Improving the CR loss budget

Piers Dawe, Nvidia

Example of switch PCB losses

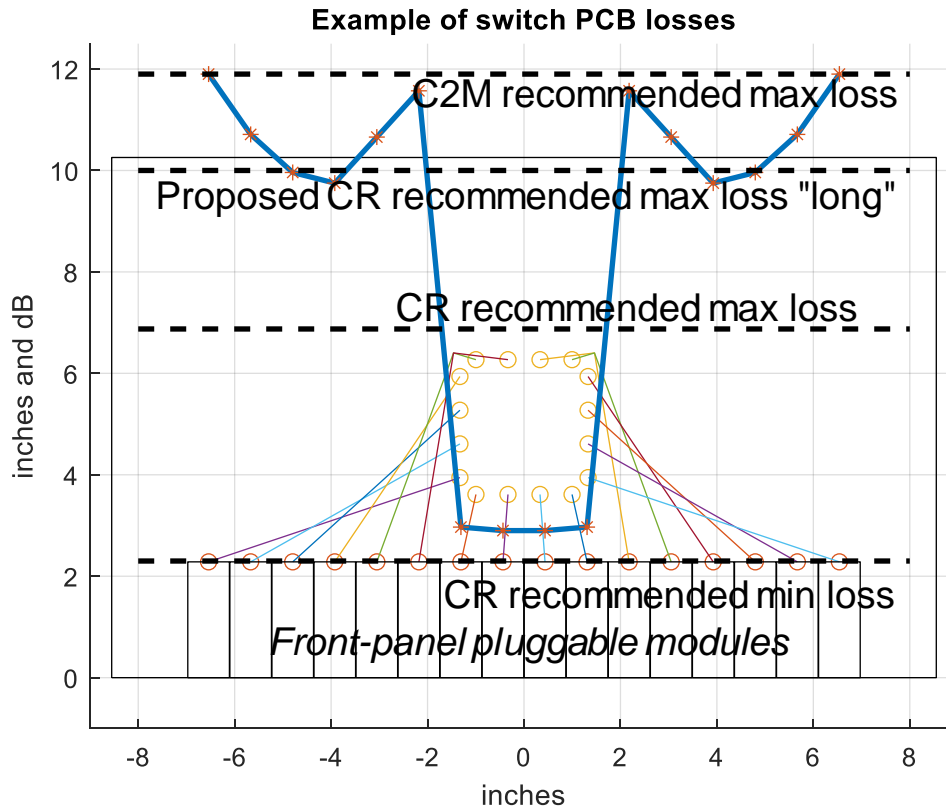
6.875/2.3 = 3:1 is too small a max/min ratio anyway

At 25G/lane and 50 G/lane we had 5.8:1

Want at least about 4:1

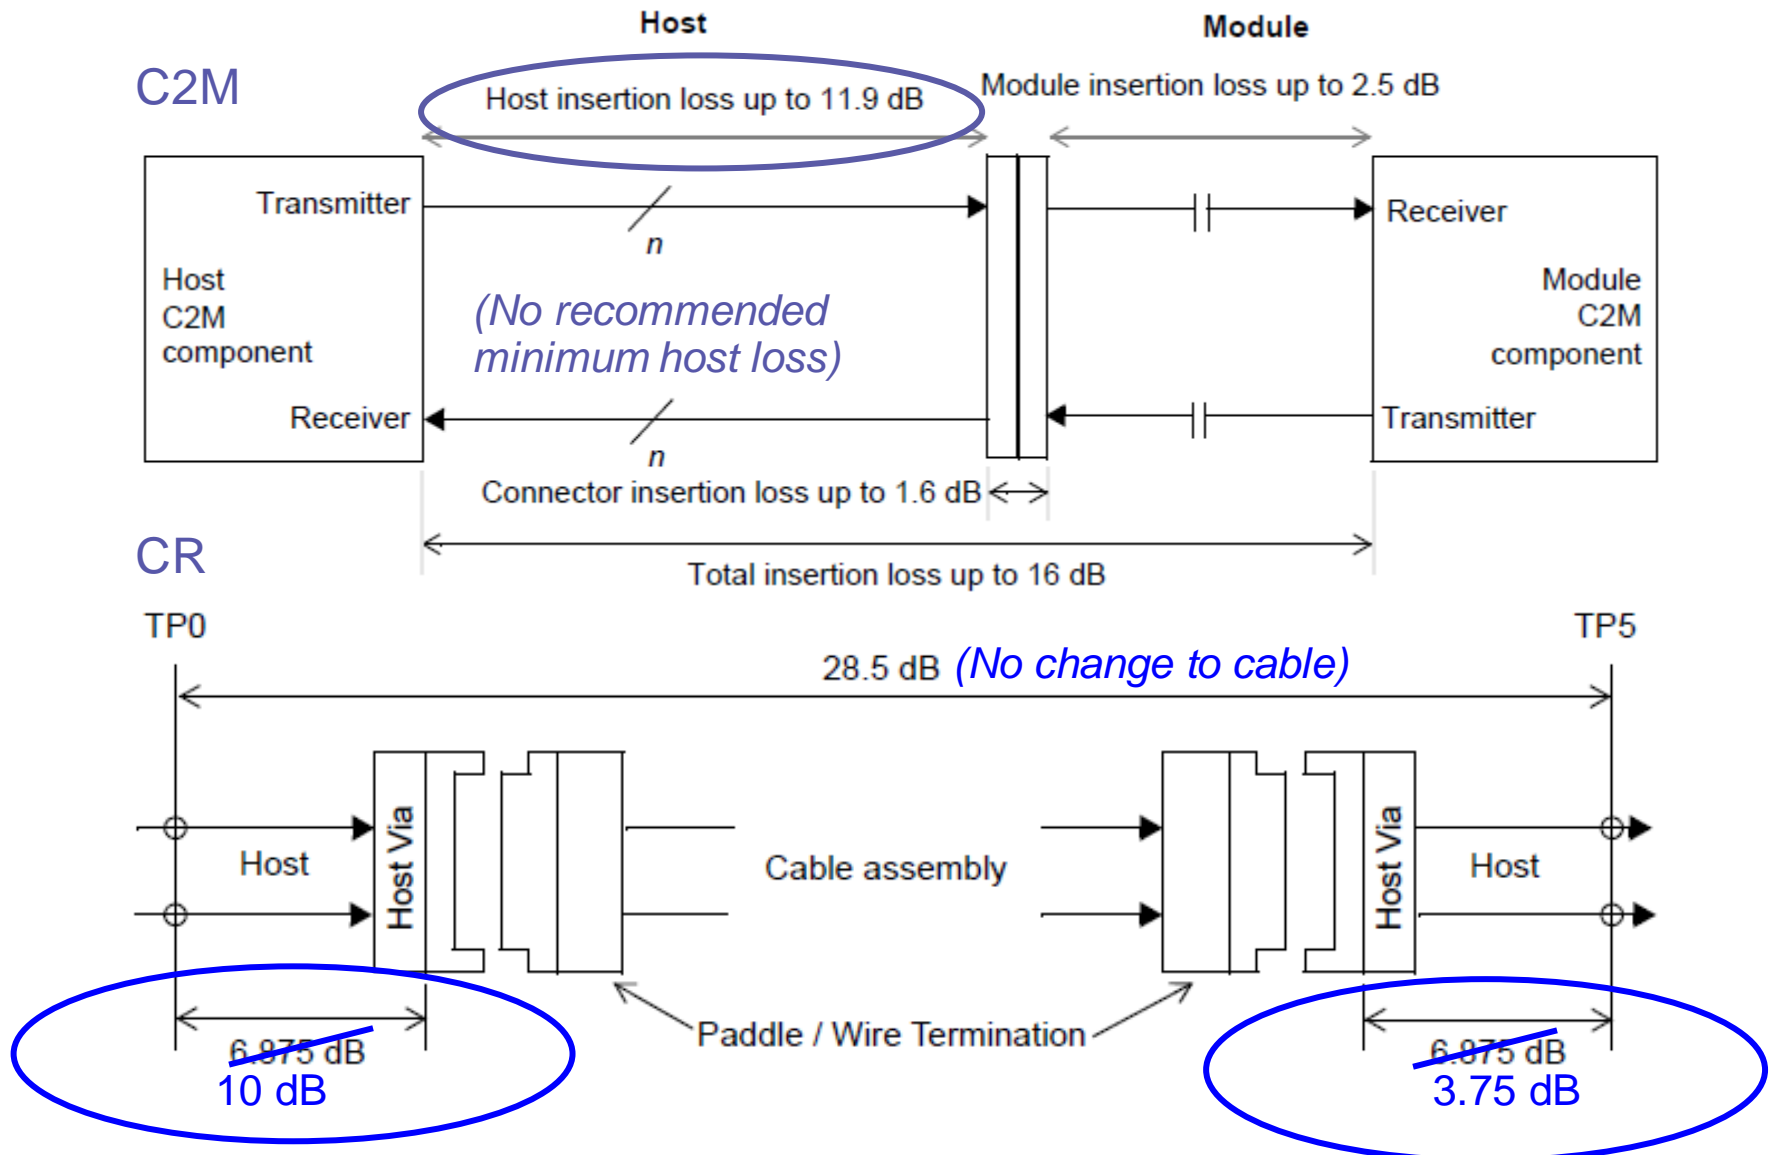
- In this example, all paths are below the C2M recommended max loss (good)
- But only 8 out of 32 are within the CR recommended max loss (bad)
- Other distributions are possible but the issue remains
- There are fixes (see e.g. [2]) but with costs
